| Project | 342-348 Victoria Street, Brunswick 322-0714 | Date | 25 November 2024 |
| Subject | 342-348 Victoria Street, Brunswick – Summary of Changes to Approved Development under MPS/2017/745/E | | |

**Planning Permit No. MPS/2017/745/A
342-348 & 368-370 Victoria Street, 13 & 15 Rosser Street and 32 Wilkinson Street, Brunswick
Request for Further Information (RFI) Response – WSUD Strategy Justification**

Drawing Name
Raingarden Scenario 1

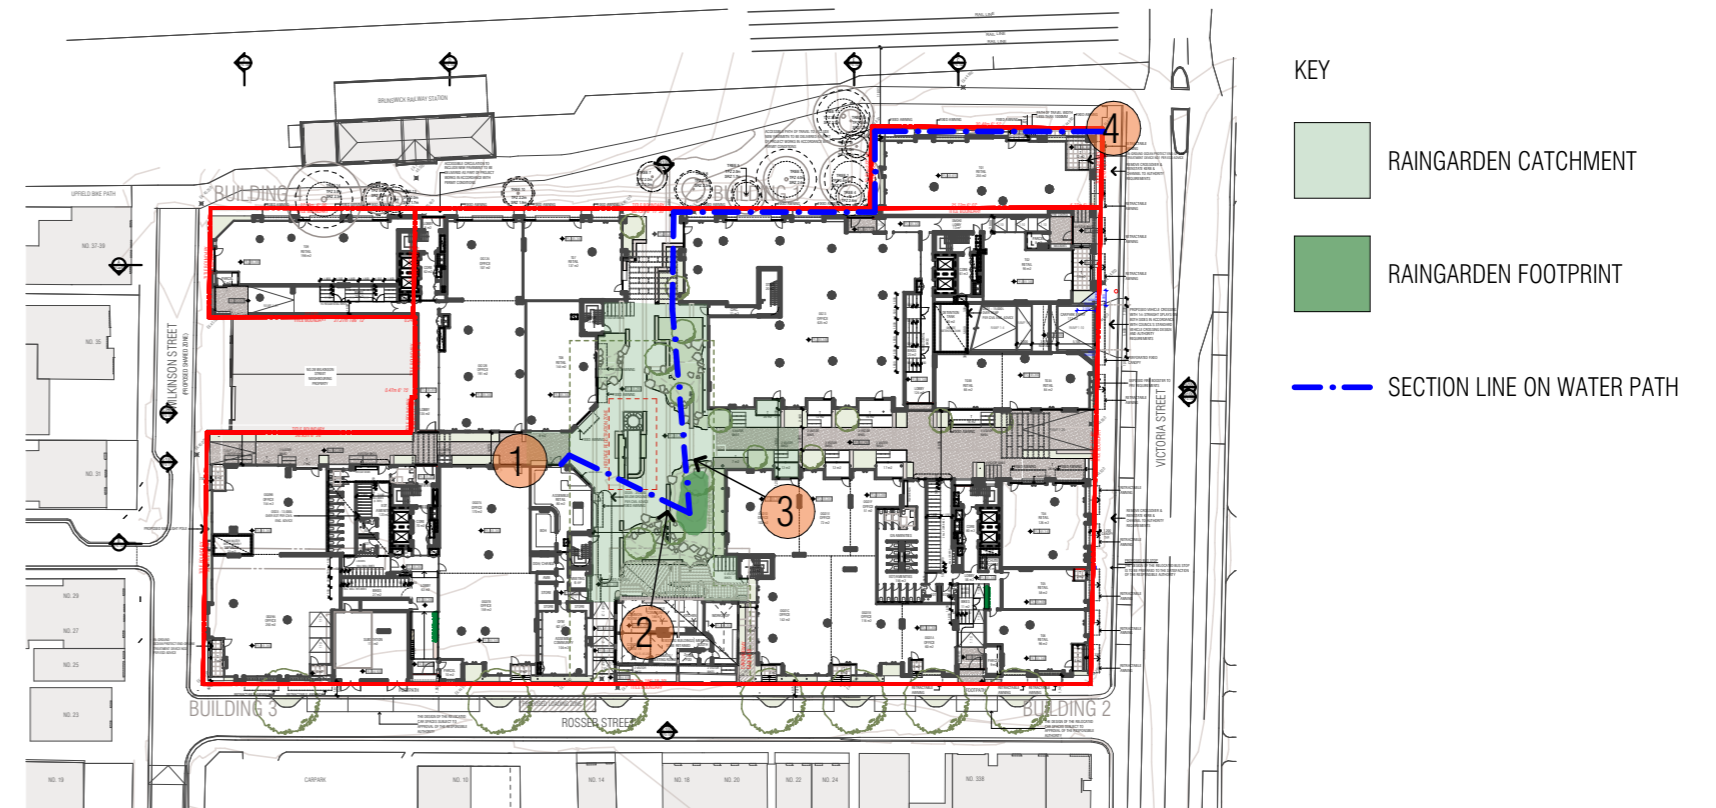
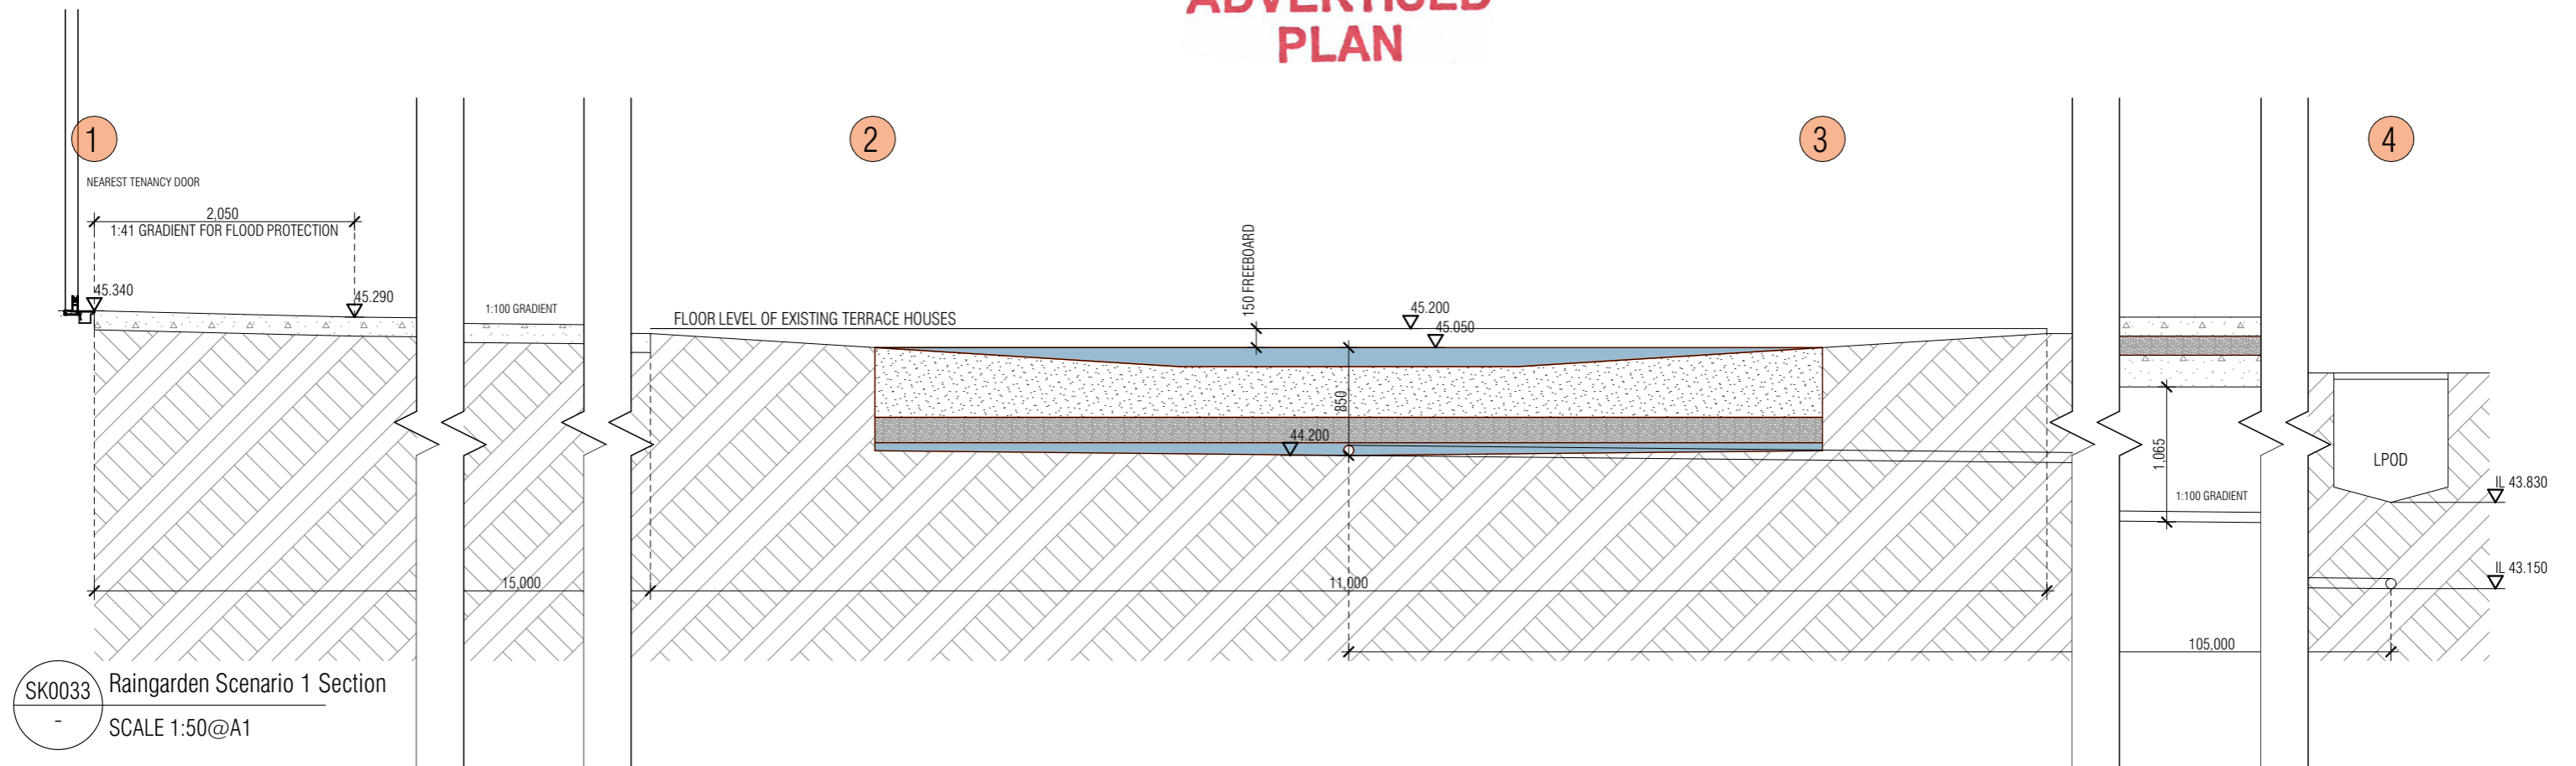
RAINGARDEN SCENARIO 1 OUTLINE

a ground-level raingarden can only catch water from a small part of the site, and cannot naturally discharge water to the LDP.

A. The raingarden level is set by the floor level (RL 45.20) of existing heritage-listed terrace houses that are adjacent to the raingarden. A 150mm freeboard is required between the floor level and the top of the raingarden's 850mm system depth. This means the highest possible Invert Level for the raingarden outlet is 44.20.

B. The distance from the raingarden to the Legal Point of Discharge is 105m, which at a pipe gradient requires a fall of 1.05m. This leaves the Invert Level of the outlet significantly lower than the Legal Point of Discharge.

C. There is a difference of 290mm between the top of the raingarden and the ground floor RL. At a gradient of 1:100 and taking into account the 50mm fall away from building entrances to prevent water ingress, this gives the raingarden catchment a range of 15m. This means that the central courtyard can drain to the raingarden, but the rest of the site will need to be drained to the currently proposed filtration system.

D. A tank and pump system could overcome the LPD discrepancy identified in item B, however it would be duplicating the tank system still required as identified in item C. This would result in a wasteful duplication of resources and maintenance for a tokenistic raingarden system.

E. There are no raingarden locations possible to the north of the one shown on the plan, due to basement below. This means that a hybrid system would remain necessary, and the raingarden would remain tokenistic.

F. Usage of tanks and pumps are not a recommended feature of raingarden design, as the process is not occurring naturally.

G. Ground floor RL should not be increased to provide a larger catchment for the raingarden, as it is already unnaturally high in order to comply with Merri-Bek's flood level, causing very challenging interfaces. The fine-grain urban design response is already stretched to its limit, and any further RL increases would result in extensive use of switchback wheelchair ramps at building entrances, and/or consolidation of entrances ie a less fine-grain design response with fewer entrances facing the street. In order to facilitate a catchment to the whole site, the ground floor would need to be raised approximately 500mm, which would result in 1.1m level differences at Victoria St.

H. The downstream pipe needs to cross the basement, and does so at a level that is an unacceptably deep obstruction in the basement, and would require the basement to be made deeper for this pipe alone, which is not feasible. The LPD could be moved to the corner of Rosser St and Victoria St to avoid this, but the LPD is shallower again.

Drawing Name
Raingarden Scenario 2

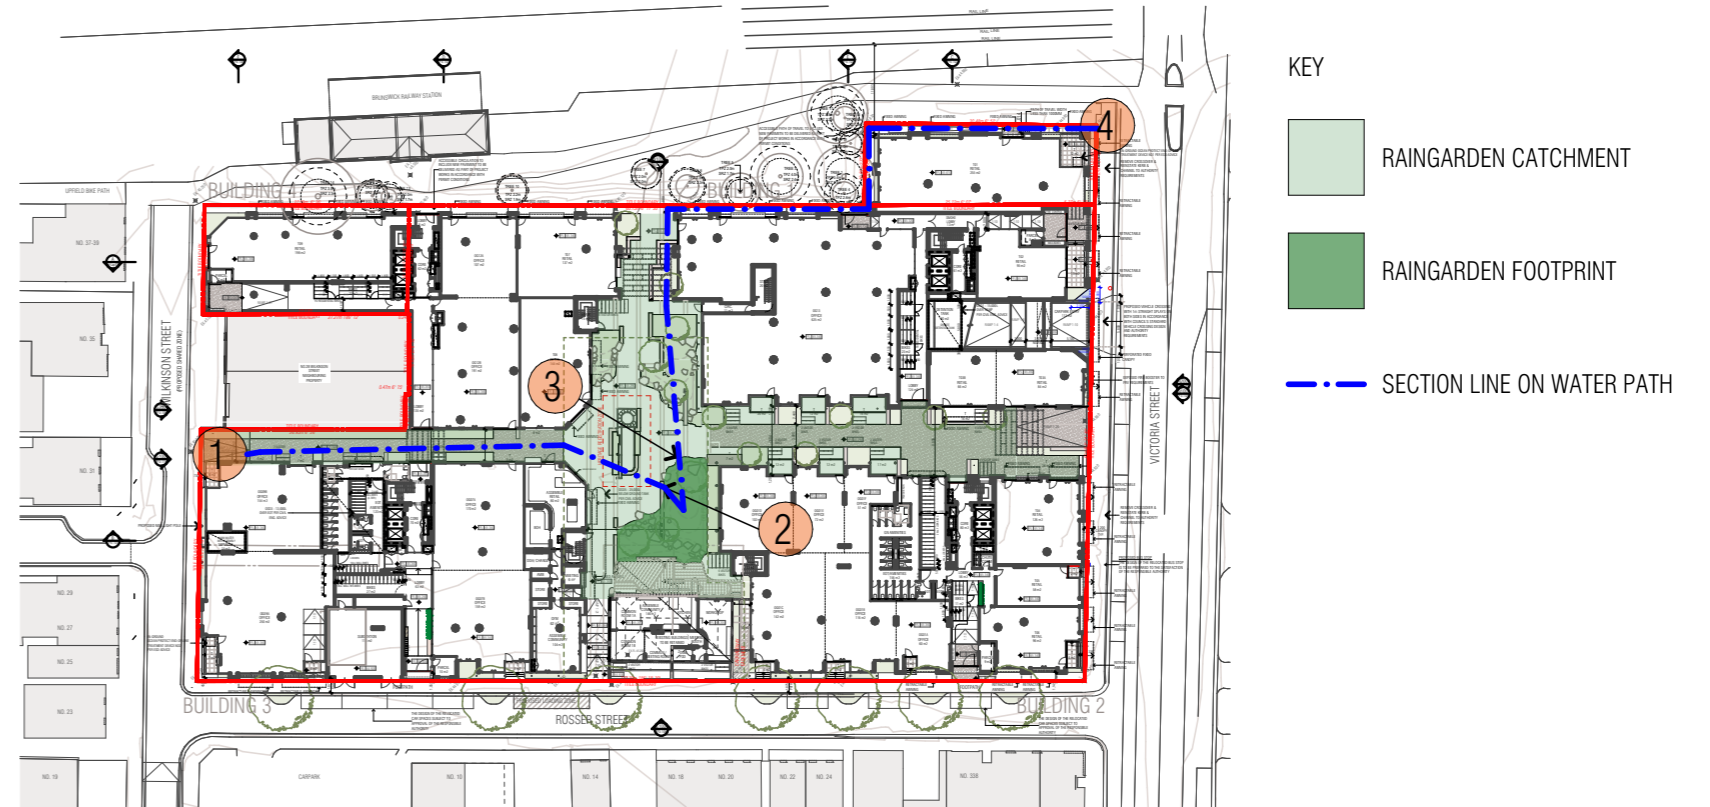
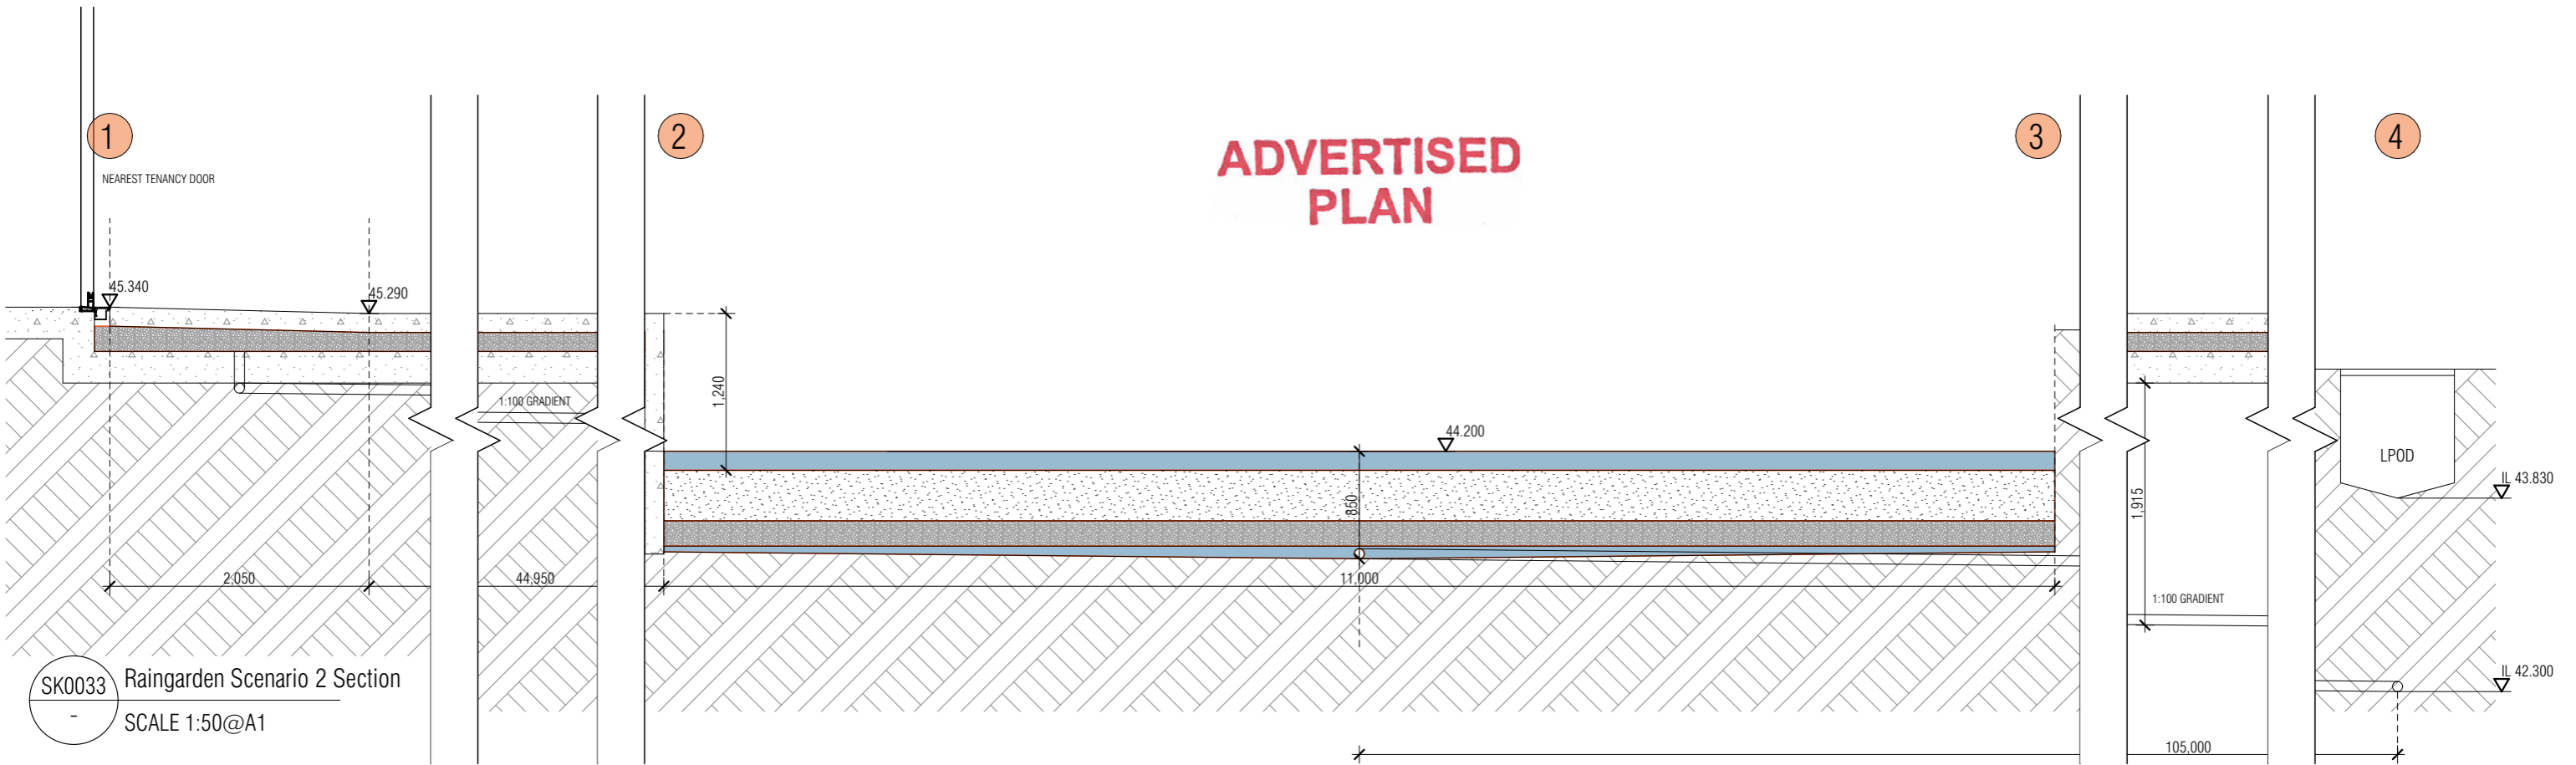
RAINGARDEN SCENARIO 2 OUTLINE

a raingarden catching water from the entire site creates fall risks, clashes with the basement, ruins a key open space and cannot naturally discharge water to the LDP.

A. In order to provide coverage to the entire site, water is directed to the raingarden via pipework under the structural slab. With a landscape buildup of 300mm, slab thickness of 250mm and a 50mm fall away from building entrances to prevent water ingress, the invert level for the pipe begins 680mm below ground floor RL.

B. The maximum distance from open landscaped areas to the raingarden is 47m, resulting in 470mm of fall to the raingarden, with drainage pipes maintaining a gradient of 1:100. This means that the pipe is 1090mm below the surrounding landscape finish by the time it gets to the edge of the garden.

C. The upstream pipe being 1090mm below landscape levels means that it is an unacceptably deep obstruction in the basement, and would require the basement to be made deeper for this pipe alone, which is not feasible.

D. There cannot be a network of local raingardens, as this would not be possible over the basement in the northern laneway, so the same maximum run would apply. Therefore, an RL of 44.20 to the top of the raingarden is the most optimistic outcome for a raingarden with a full site catchment.

E. With the top water level of the raingarden at RL 44.20, the 1.2m fall from the path to the garden bed presents a safety hazard, and would require a balustrade to prevent falls, it would then also require a staircase out of the ditch to prevent entrapment. If a smaller drop from the path edge were provided, with graded soil providing the rest of the level change, there would still be a safety in design risk that would need to be mitigated with the same features.

F. Because of the levels and fencing, this large garden would no longer function as an active play space for children, as it would present as a ditch rather than a garden. The site would be losing a key communal open space and gaining a stormwater asset.

G. Downstream from the raingarden, at a gradient of 1:100, the drainage pipe would arrive at the location of the Legal Point of Discharge at an RL significantly lower than the LPOD. This could be overcome with a tank and pump, although this is not a recommended raingarden design feature.

H. The downstream pipe needs to cross the basement, and does so at a level that is an unacceptably deep obstruction in the basement, and would require the basement to be made deeper for this pipe alone, which is not feasible. The LPOD could be moved to the corner of Rosser St and Victoria St to avoid this, but the LPOD is shallower again.
